Elevation 3 - North West Elevation of Block 4

Elevation 4 - North East Elevation of Block 4

Contract: Barratt North London
Comet Square Phase II, Hatfield
Title: Block 4 Elevation 3 & 4

Drawing No.	Rev.
G2120 B4(20) 221	F
Scale:	1:100@A1
Date:	July 2005
Drawn:	dk
Checked:

Roof Penetrations

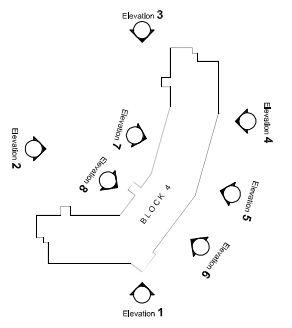
To be added to drawing:
